Evaluation of Existing WEPP Model Output

Poplar River Turbidity Total Maximum Daily Load Evaluation of Existing Model Output

Task Order No. 2006-47

September 21, 2007

**Figure 1. Lower Poplar River watershed as delineated in the Cook County AUAR.
This is figure 5-1 in the AUAR. No scale is provided in the original.**

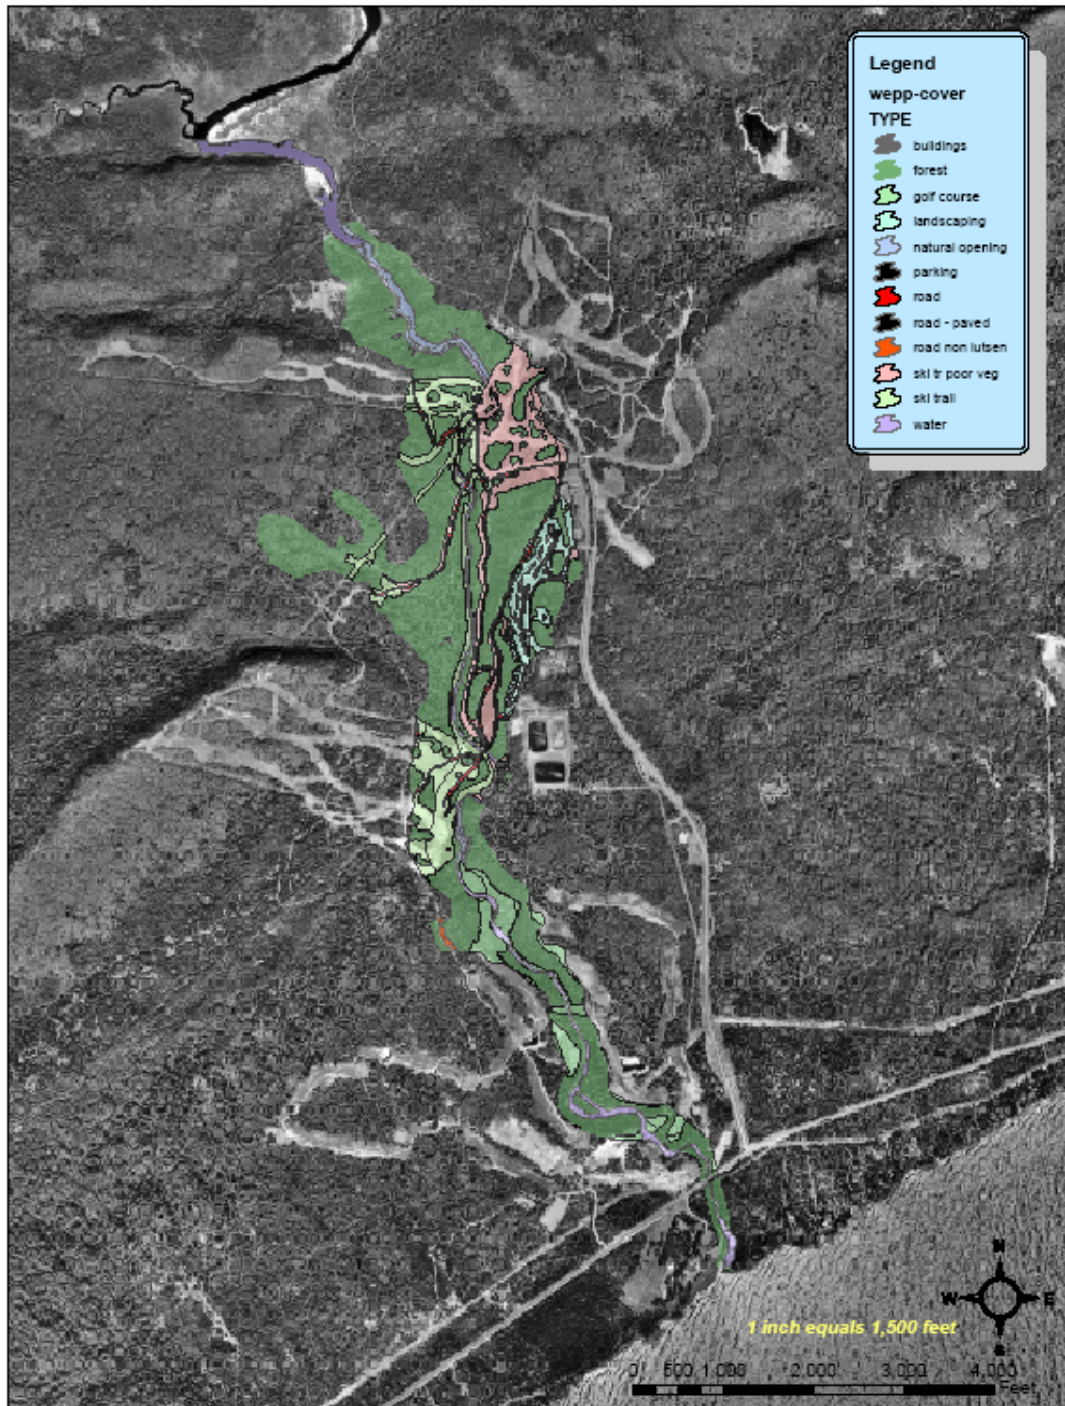
Furthermore, the WEPP modeling did not include all of the land area in the lower Poplar River watershed. According to the Lutsen Environmental Report (NAWE, 2005) the lower Poplar River watershed is 1,317 acres. The WEPP modeling was limited to the Poplar River gorge subarea, which is 274 acres (NAWE, 2005). This area was the focus of the WEPP modeling, according to Lutsen Resorts, because due to its steep sloping topography it is the most probably area to contribute sediment to the Poplar River (NAWE, 2005). Figure 1 shows the watershed boundary of the lower Poplar River as delineated in the Cook County Alternative Urban Areawide Review (AUAR). Figure 2 shows the boundary of the Poplar River Gorge subarea modeled using WEPP. Although the scales of Figures 1 and 2 are different, they clearly show that the gorge area is a subset of the lower Poplar River watershed. In addition, the aerial photograph used as the background for Figure 2 indicates that ski trails, buildings, roads, and other developed roads exist outside the gorge area and within the lower Poplar River watershed. These areas have the potential to contribute sediment to the river.

- Only a limited portion of the lower Poplar River watershed is used, and;
- Transport of sediment is not simulated.

These weaknesses should be addressed. The limited spatial extent of the modeling should be expanded to include the entire lower Poplar River watershed. The Poplar Gorge area may contribute significant sediment loads directly to the Poplar River due to steep slopes and close proximity to the river; however, areas of the watershed further from the river will also contribute sediment via intermittent drainage channels, roadside ditches, gullies, and other drainage channels and, therefore, should be included in the analyses.
